**JOINT PUBLIC HEARING**  
THE CITY COUNCIL CITY AND THE PLANNING AND ZONING COMMISSION OF  
THE CITY OF PEARLAND, TEXAS,  
**MONDAY, MARCH 28, 2016, AT 6:30 P.M.**  
COUNCIL CHAMBERS - CITY HALL-3519 LIBERTY DRIVE

**Zoning Change Application No. 2016-05Z**

## Staff Report

Re: Zone Change Application No. 2016-05Z

# SITE PLAN - PEARLAND STORAGE

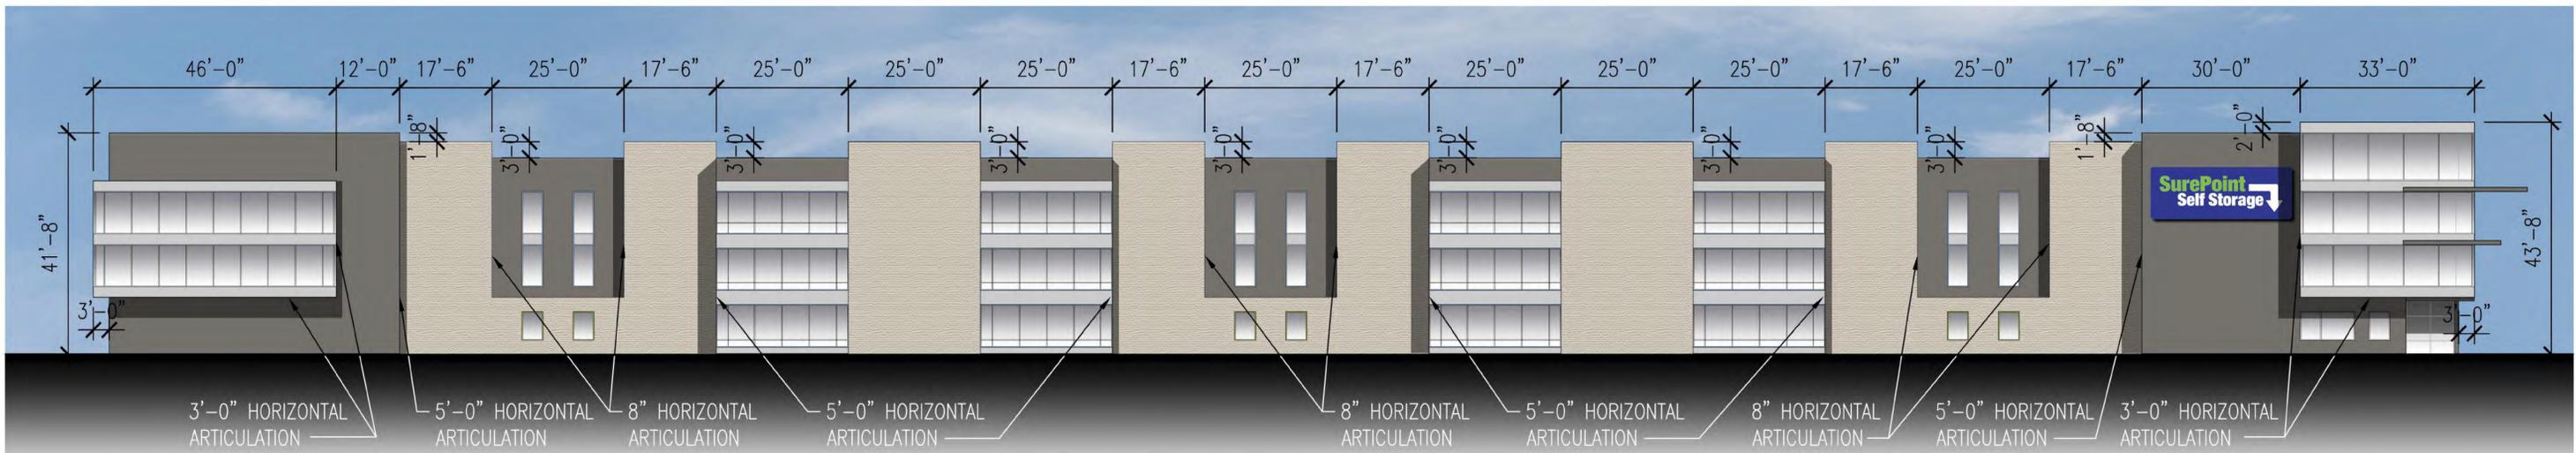
A storm drainage pipe exists through the property and falls under the proposed building. Staff has spoken with Andrea Broughton, Brazoria County Drainage District #4 (BDD4) who stated that there is no easement recorded for this drainage pipe. Relocation of the pipe within a drainage easement may be possible but the applicant must work with the City and BDD4 to accomplish this. If the pipe cannot be relocated, this site plan must be revised as no building can be built over a drainage pipe.

**SITE PLAN**

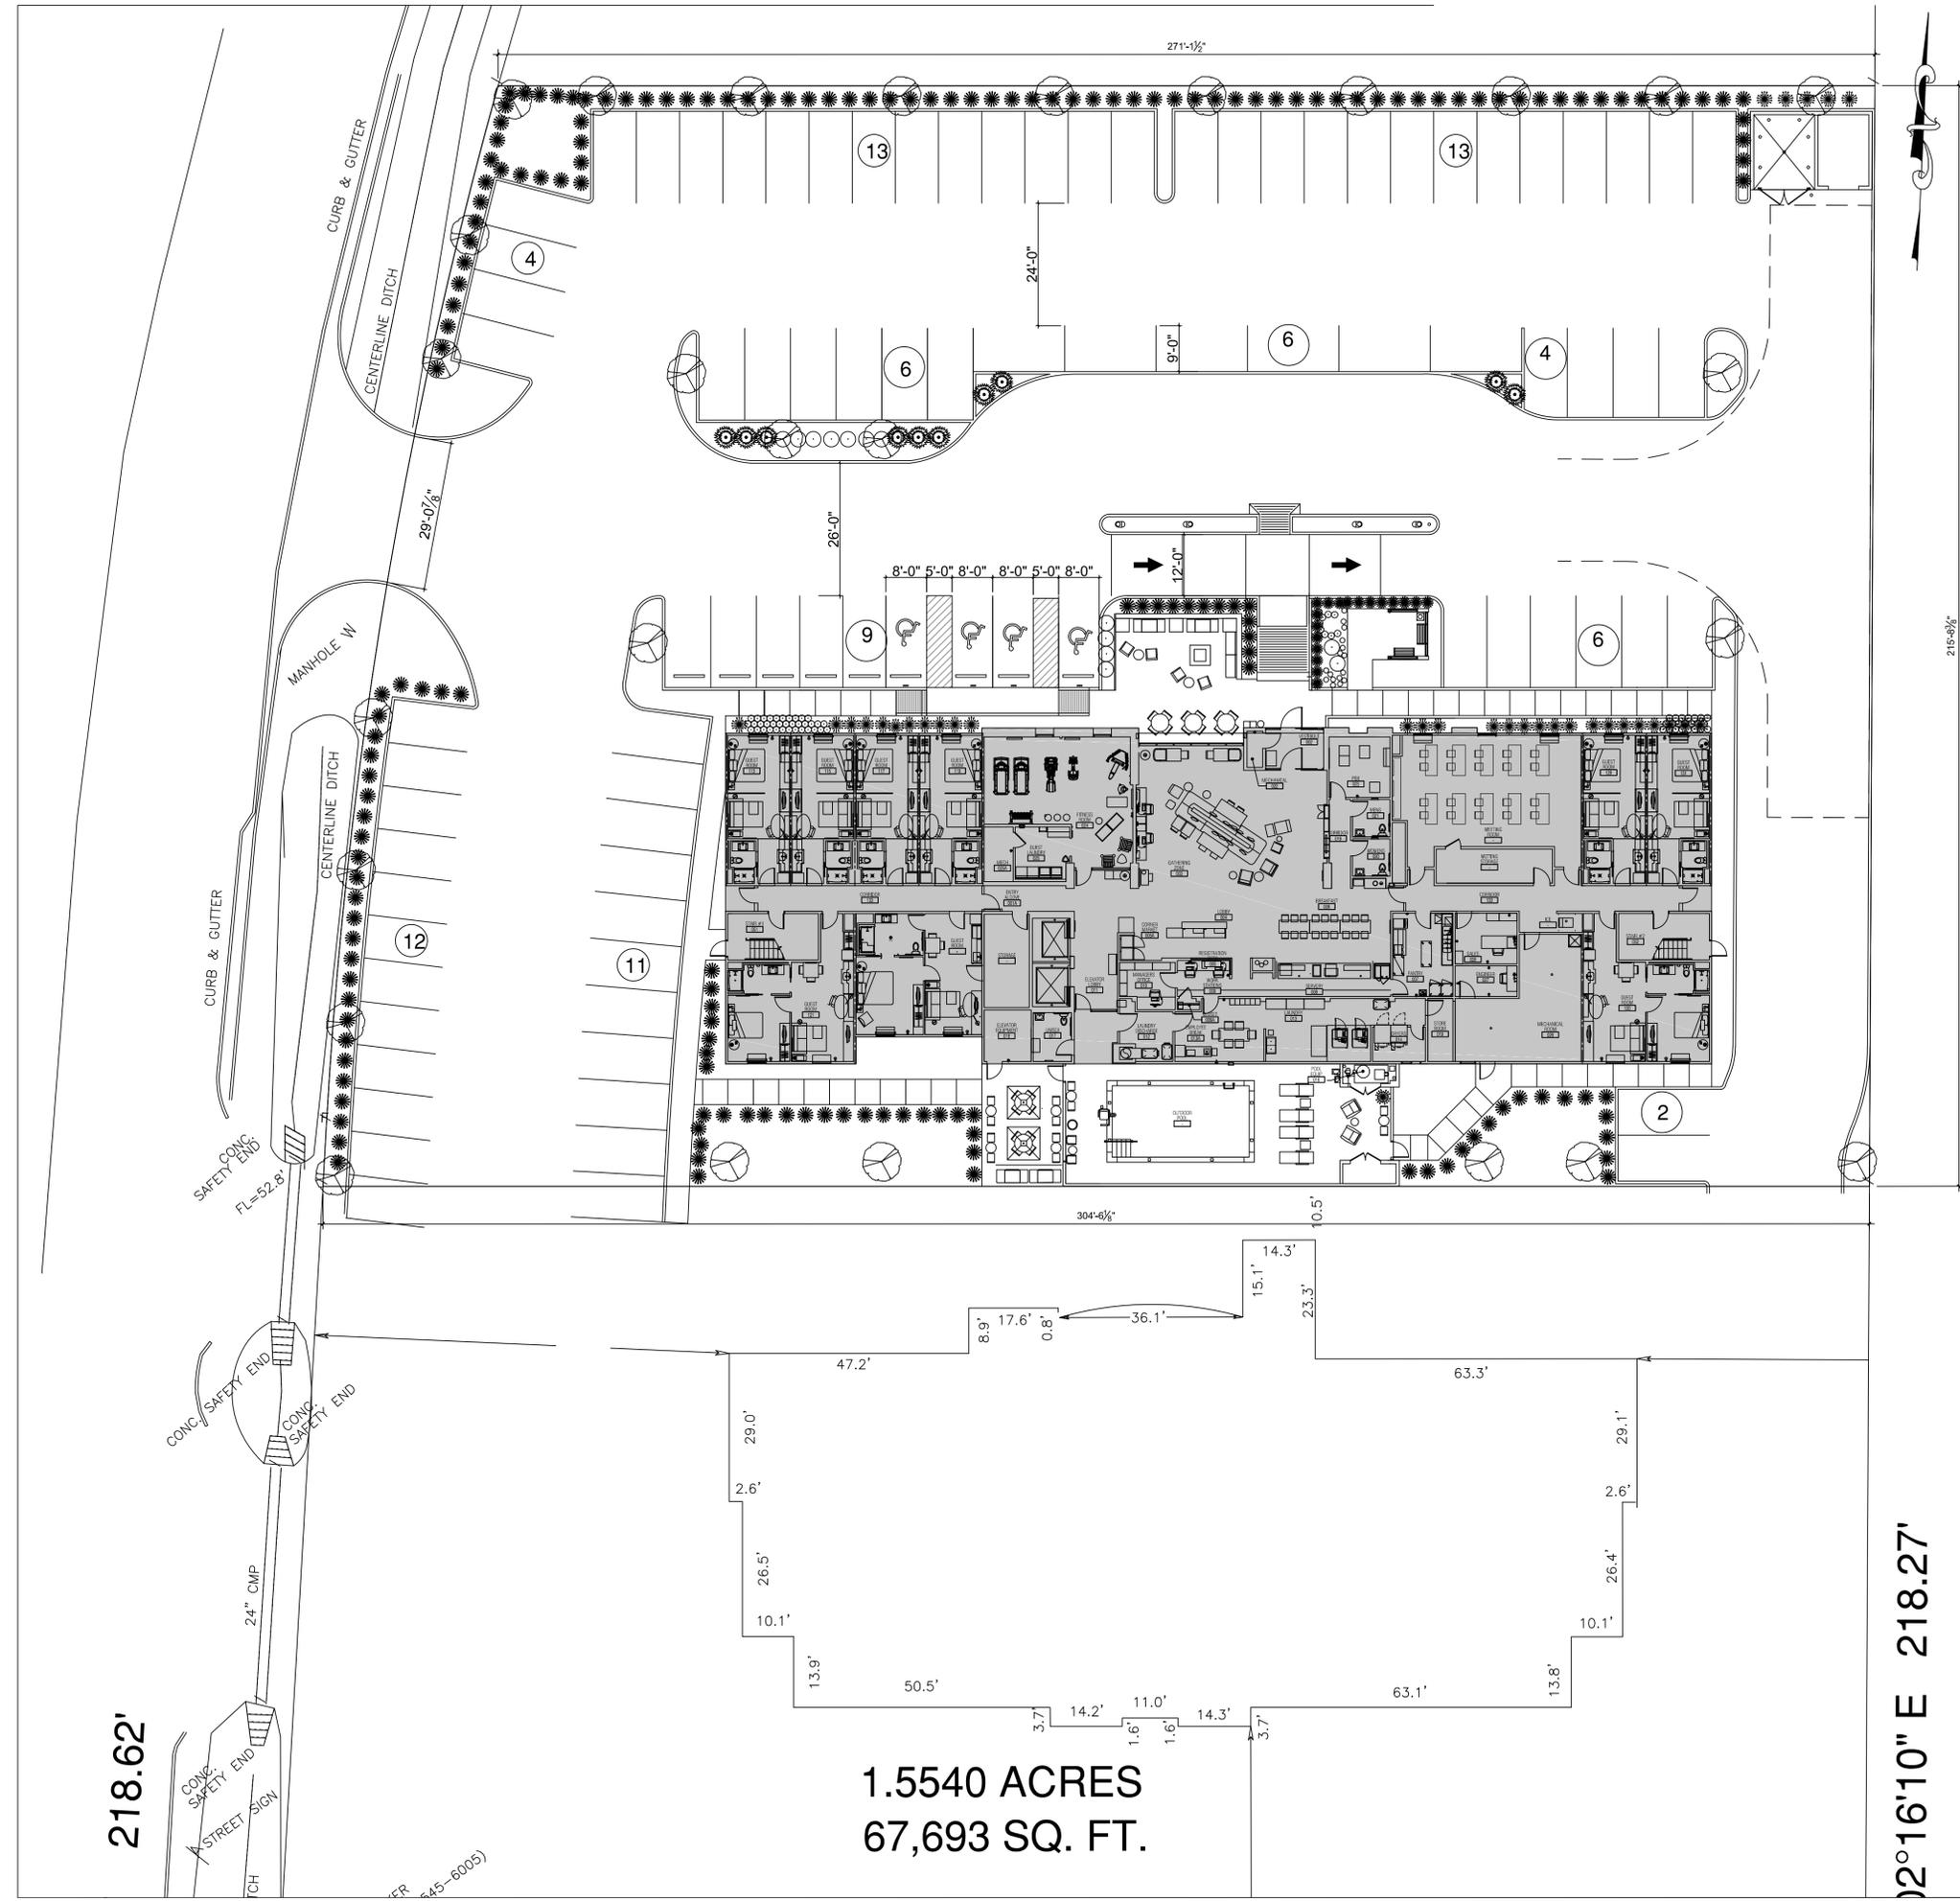
1. The applicant shall clearly demonstrate that the landscaping shown on the Site/Landscaping Plan (C3.0) meet the landscaping standards required by the Unified Development Code (UDC).
2. Building elevations as submitted are not legible. Provide readable drawings showing conformance to all requirements of the BP-288 zoning district standards, including building façade standards (transparency, articulation, etc.)
3. Building façade materials for facades visible from SH 288 (north, south, and west facades) shall be limited to no more than thirty percent (30%) stucco. A combination of brick, stone, and other masonry materials shall be used.
4. The unused driveways approaches from the frontage road will be removed.

**Figure A.2 – Vacant Land and Management Districts (as of 2014)**

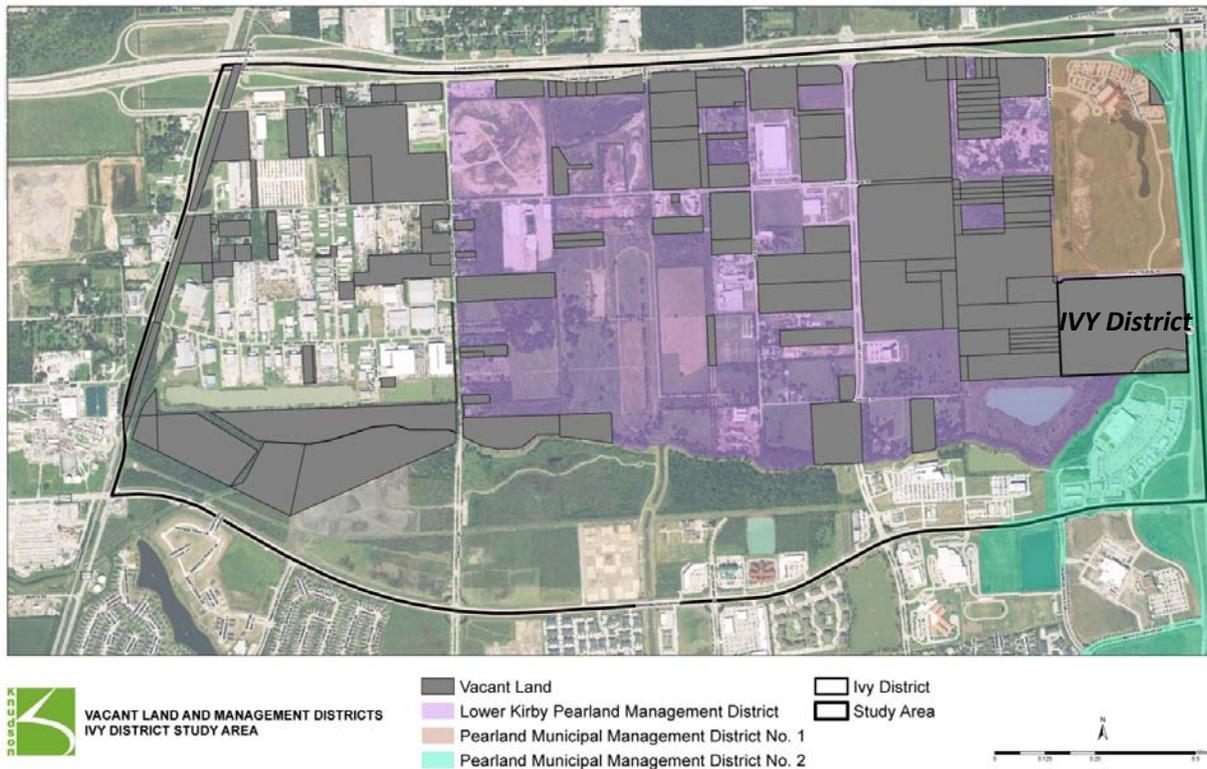
2. Update Figure A.2. Some vacant land is developed.
3. Page 6 – The difference between zoning districts and land use categories need to be clear.
  - a. 1<sup>st</sup> para – second line, remove the words “... three separate zoning designations, also known as Character zones’ ...”
